**MODIFICATION TO CONCEPT PLAN APPROVAL FOR DAN LAND 290
& 302 MINMI ROAD FLETCHER (MP06_0031 MOD3)**

The supplementary documentation has been reviewed by Council officers and the following comments are offered for your consideration:

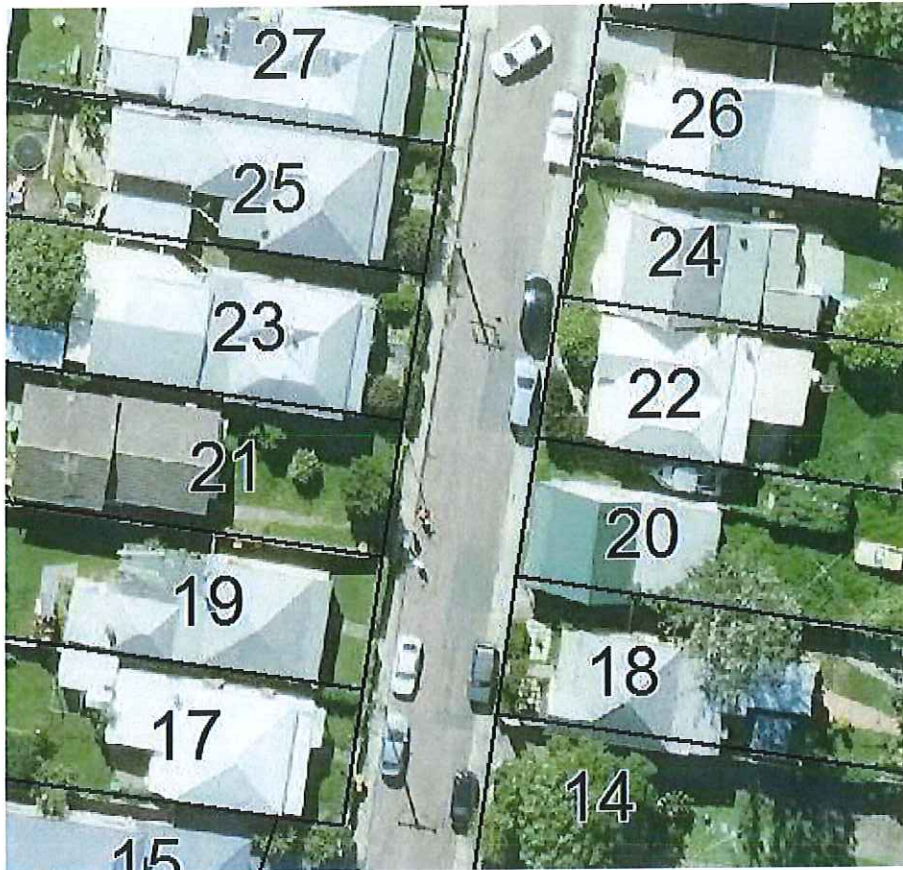
Below are photos of a road in Wallsend having a carriageway width of 6.5m and typical lot frontages of around 10m. As can be seen, even at this carriageway width residents find it necessary to park on the footpath to provide enough room for one car to travel down the middle of the road. It is acknowledged that not all lots have off street parking opportunities and the reduced front building setback limits opportunity to provide stacked parking on the lot.
